Monitoring Report – Year 2
FINAL VERSION
Edwards-Johnson Mitigation Project
Calendar Year of Data Collection: 2019

RE: WLS Responses to NCDEQ DMS Review Comments for Task 8 Draft Monitoring Report Year 2 for the Edwards-Johnson Mitigation Project, NCDEQ DMS Full-Delivery Project ID #97080, Contract #006825, Neuse River Basin, Cataloging Unit 03020201, Johnston County, NC

Project Name	Edwards-Johnson Mitigation Project
Project ID	97080
Reach ID	R3
Cross Section ID	X5
Field Crew	K. Obermiller, E. Dunnigan

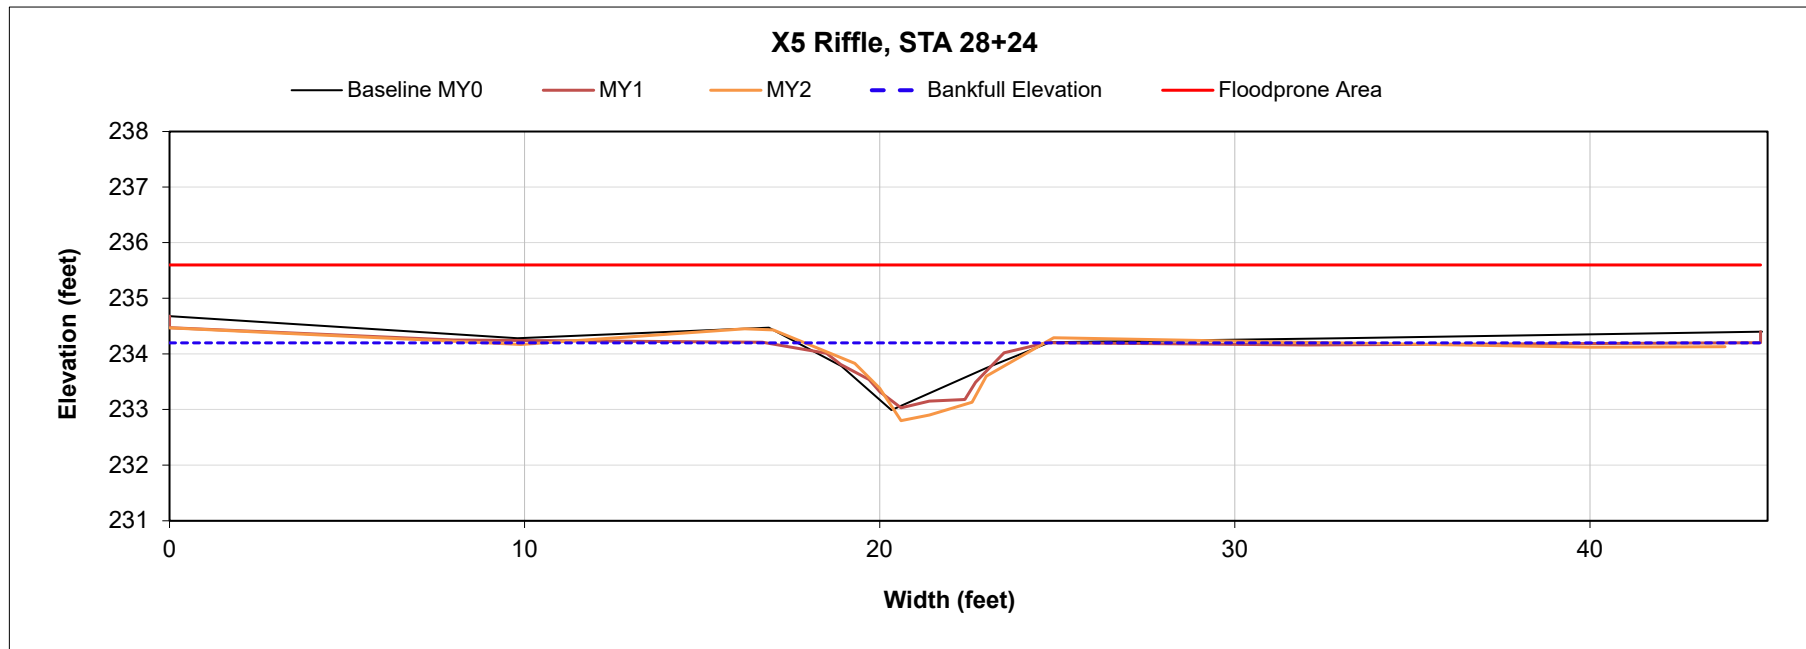
8. **DMS Comment: X5- check change from BHR (looks like it should be positive, not -10%).** WLS Response: WLS has checked all BHR's to remove any negative percentages.
